Environmental Impact Statement for an Early Site Permit (ESP) at the North Anna ESP Site

Appendices E and F

**U.S. Nuclear Regulatory Commission
Office of New Reactors
Washington, DC 20555-0001**

Figure 1.2-1 Ephemeral Stream Locations
Source: Lake Anna West, VA, USGS 7.5 Minute Topographic Map, 1983.

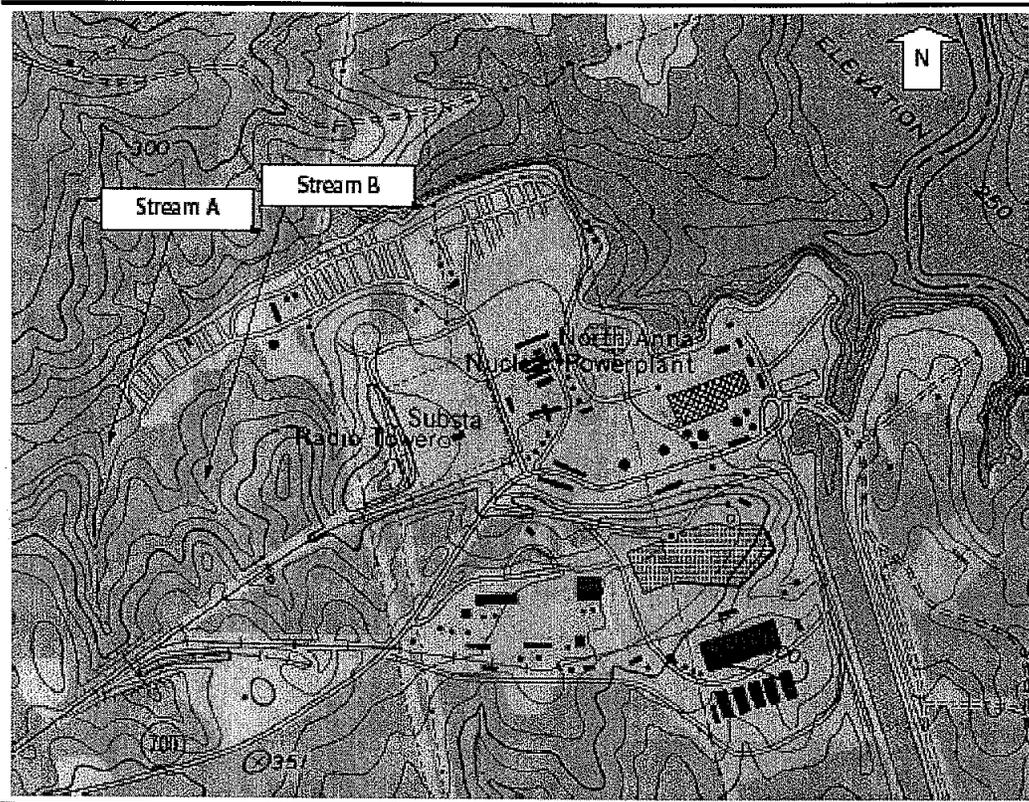
Portions of two small ephemeral streams that discharge to Lake Anna, designated Streams A and B on Figure 6, may be filled to level the area should the construction of cooling towers in that area become a part of the final plant design. Dominion estimates that about 1500 feet of stream channel would require filling. The site drainage system would be designed to incorporate the flow currently conveyed by these streams to the lake. By providing alternate drainage facilities to convey the stream flows, no short-term or long-term adverse hydrologic impacts on site drainage would result. Therefore, the need to redress the streams to their original condition, should construction be terminated, would be evaluated at that time to determine the best way to ensure long-term stability of the site. If considered necessary, the stream channels would be re-excavated and stabilized by vegetation and/or riprap to return the area to an acceptable long-term condition.
